**MONTICELLO NUCLEAR GENERATING PLANT**  
Docket No. 50-263 License No. DPR-22

**Supplemental License Amendment Request and Response to Request for Additional Information Regarding License Amendment Request for Revision to Standby Diesel Generators Technical Specifications and Surveillance Requirements (TAC No. MB3042)**

Supplemental License Amendment Request and Response to Request for  
Additional Information Regarding License Amendment Request for Revision to  
Standby Diesel Generators Technical Specifications and Surveillance Requirements

DG Air Starting System Schematic Diagram

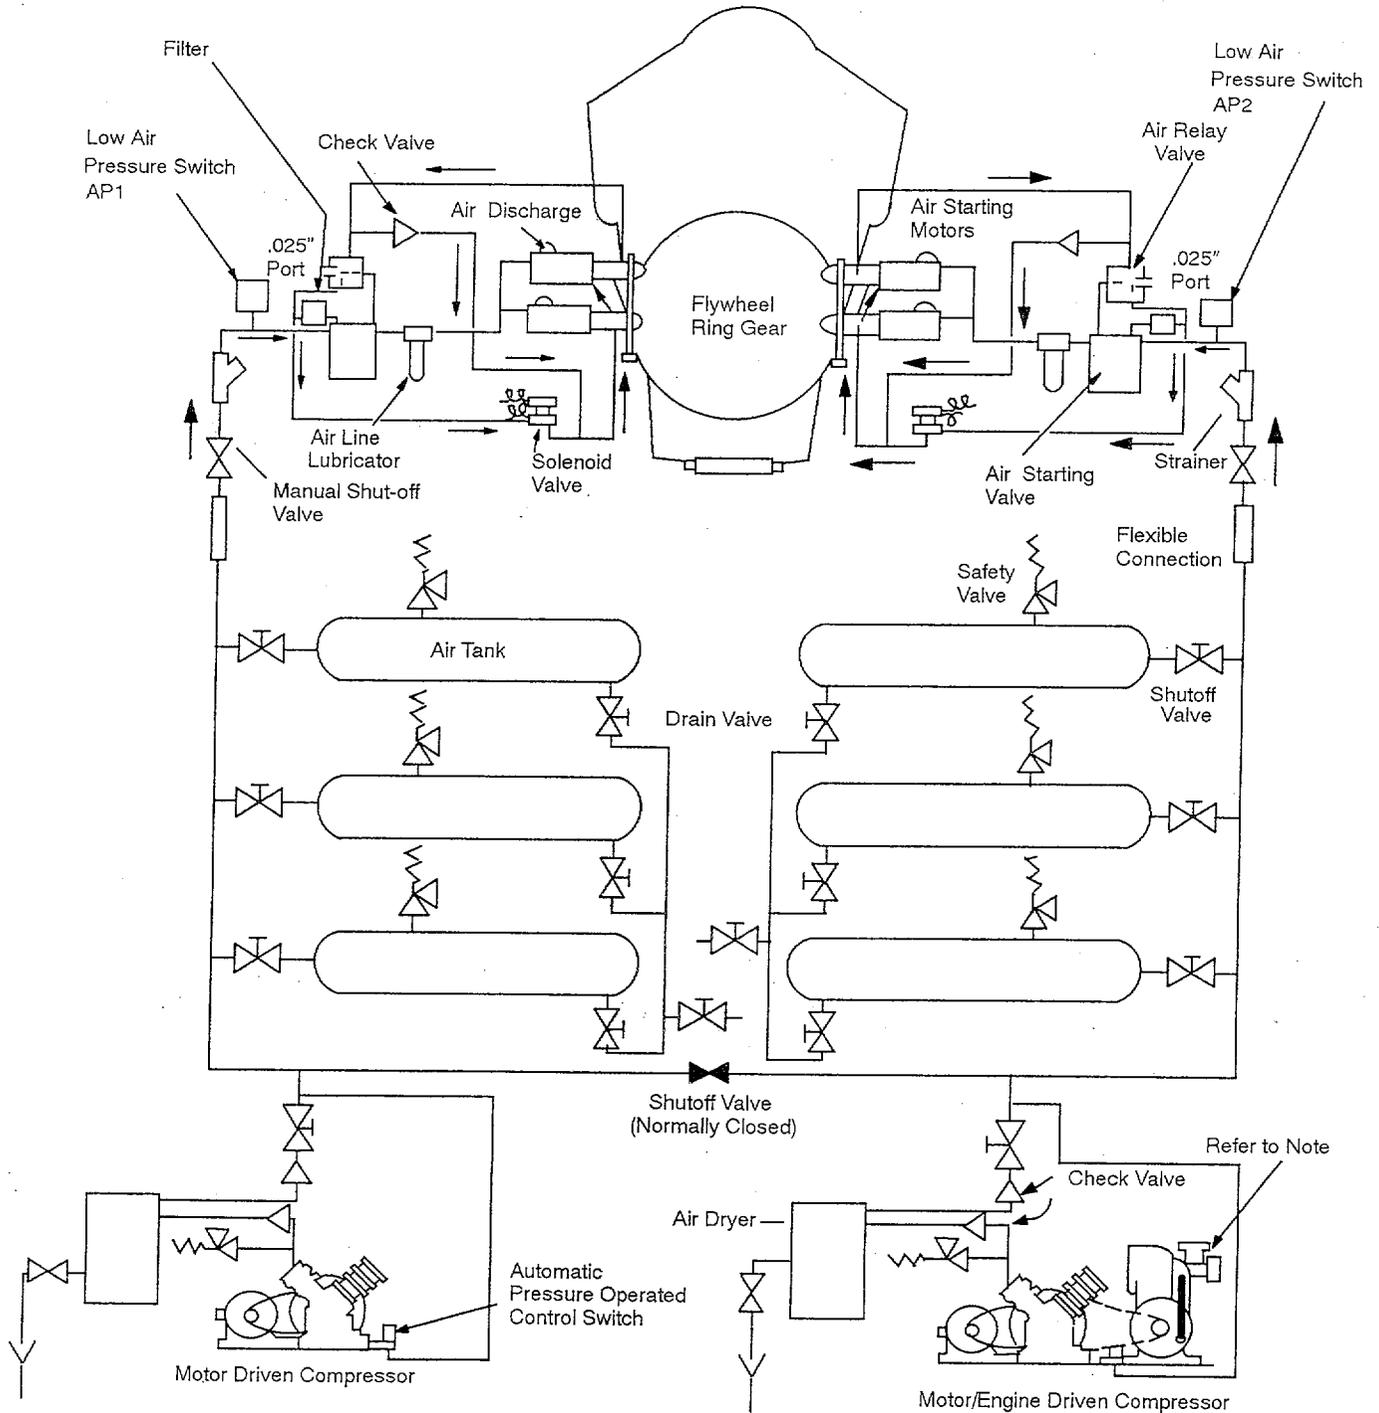
2. Please address the potential common-cause failure modes which may be possible given that one diesel generator starting air receiver pressure is less than the minimum pressure requirement (i.e., 165 psig) under the proposed LCO TS 3.9.B.3.c and identify any independent means which will verify that the remaining air receiver has sufficient capacity to provide enough air pressure for a minimum of two emergency diesel generator (EDG) starts.

The starting air receivers for each Diesel Generator at Monticello are independent and redundant, but not diverse in that each receiver has like components. The starting air receivers are cross-connected by a manual valve, but there are no active air system failures which could effect both starting air receivers. The like components, similar to other like components in the plant, may create a potential for common-cause failures. Upon failure or degradation of one starting air system, operations personnel will monitor the pressure of the redundant starting air receiver on a once per shift basis. The failure of a starting air receiver component will be reviewed, by plant personnel, to determine the root cause of the failure. This review will include the potential for a common-cause failure, of like components, for the other starting air receivers. The remaining starting air receiver will have sufficient pressure for a minimum of three (3) diesel generator starts, from 165 psig, as demonstrated by the Bechtel start-up test data.
